SHOP FACILITY

GRANT COUNTY
PUBLIC WORKS DEPARTMENT
ROAD DISTRICT NO. 3
QUINCY, WASHINGTON

AS BUILT DRWG'S

ADDENDUM NO. 1
ATTACHMENT No. 1

SITE PLAN – ELECTRICAL
SCALE: 1" = 40'-0"

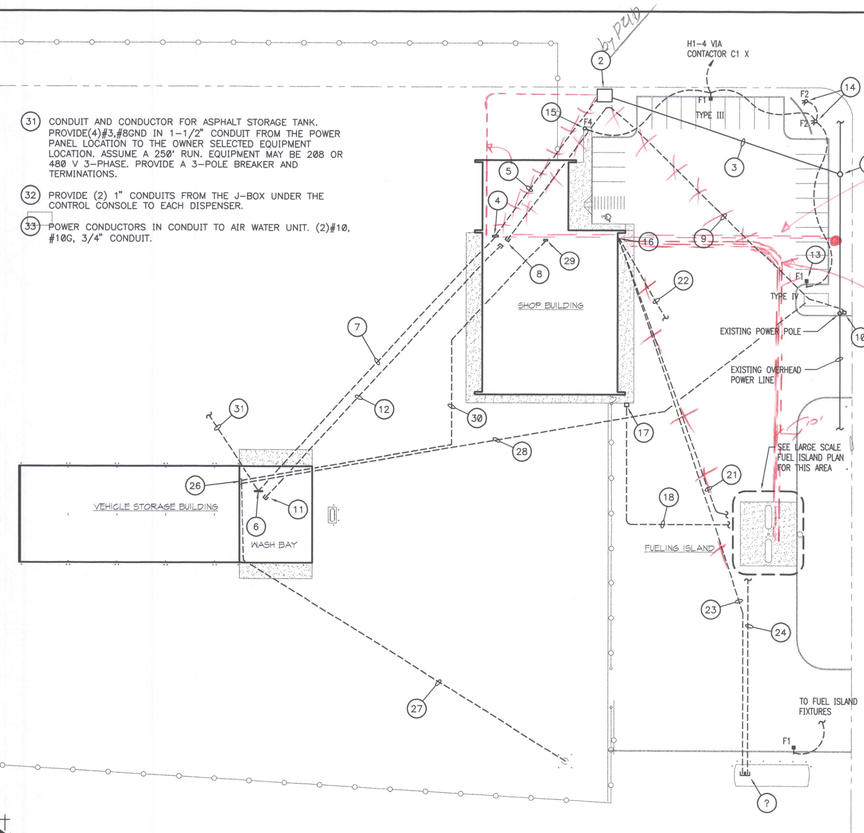
6. LOCATION OF THE DISTRIBUTION PANELS FOR VEHICLE STORAGE BUILDING.
7. **Item No27:** Sheet E1.1: Keyed note #7 should call the conduit to be run from panel MDP to panel VH1. :L. PROVIDE SEAL FITTINGS AT EACH END.

SHOP BLDG. FLOOR PLAN – LIGHTING

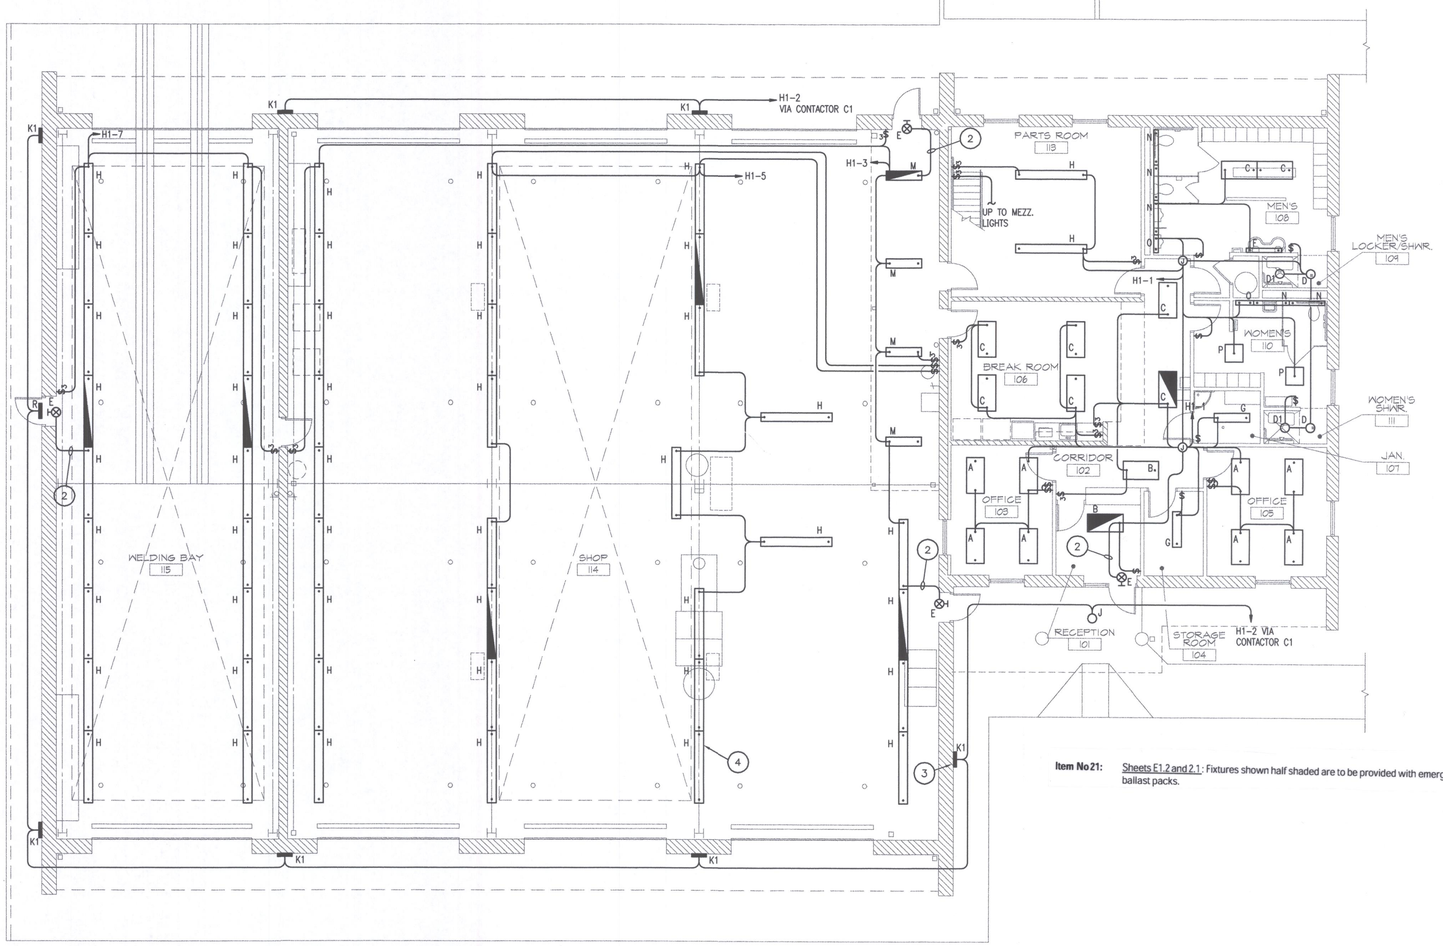
Item No 21: Sheets E1.2 and 2.1: Fixtures shown half shaded are to be provided with emergency ballast packs.

SHOP AREA – MEZZANINE

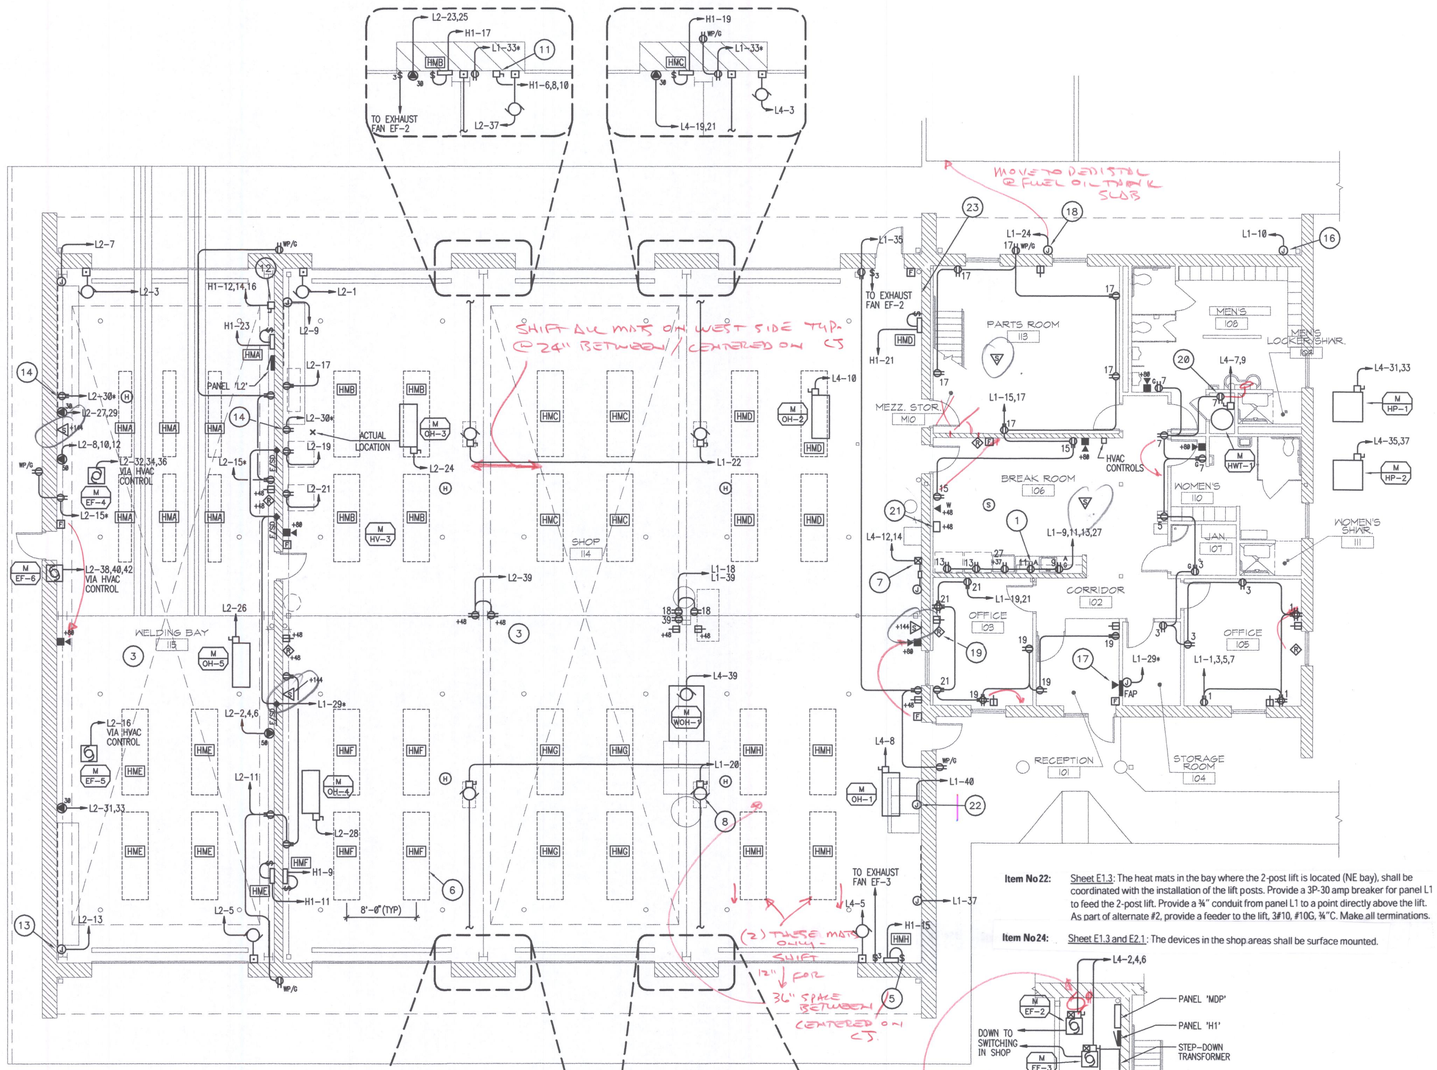
7. **Item No.25:** Sheet E1.3: The buck-boost transformer called out in keyed note 7 shall be a 5kVA 208:240 volt, 1-phase unit and shall be mounted to the wall surface at +72".

Item No.22: Sheet E1.3: The heat mats in the bay where the 2-post lift is located (NE bay), shall be coordinated with the installation of the lift posts. Provide a 3P-30 amp breaker for panel L1 to feed the 2-post lift. Provide a ¾" conduit from panel L1 to a point directly above the lift. As part of alternate #2, provide a feeder to the lift, 3#10, #10G, ¾"C. Make all terminations.

Item No.24: Sheet E1.3 and E2.1: The devices in the shop areas shall be surface mounted.

COVERED STORAGE FLOOR PLAN - LIGHTING/POWER/SYSTEMS

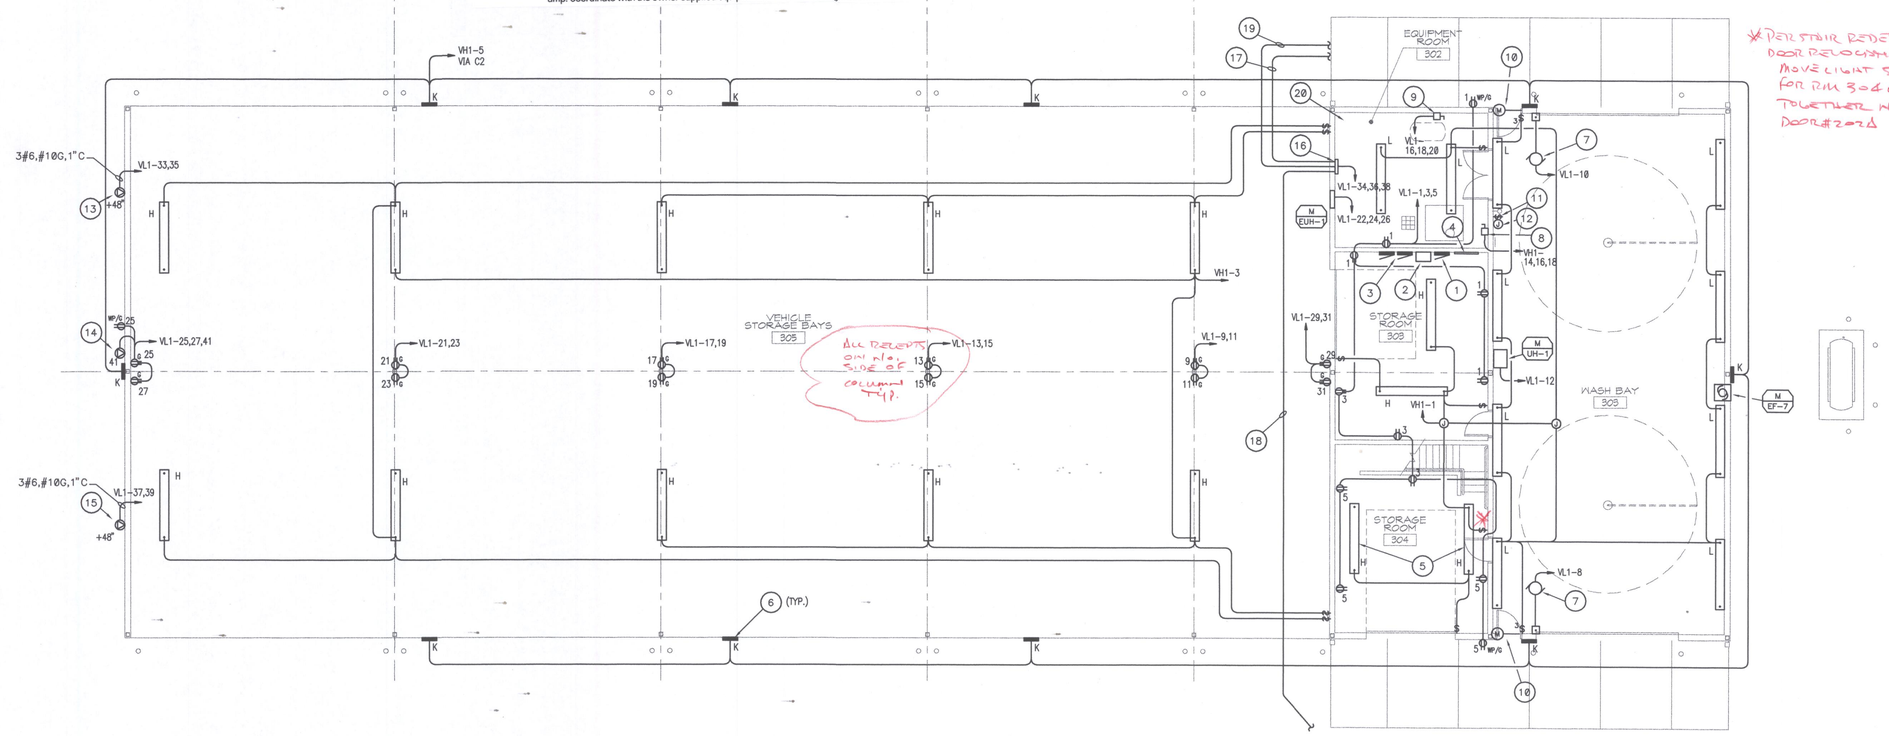
Item No23: Sheet E2.1: The receptacles called out in keyed notes #13, 14, and 15 shall be 'all weather' labeled. The receptacles called out in keyed notes 13 and 15 shall be 208 volt, 1-phase, 60-amp. Coordinate with the owner supplied equipment for the final configuration.

* PER STAIR REDESIGN! DOOR RELOCATION & MOVE LIGHT SWITCHES FOR RM 304 & STAIRS TOGETHER NEXT TO DOOR #207A
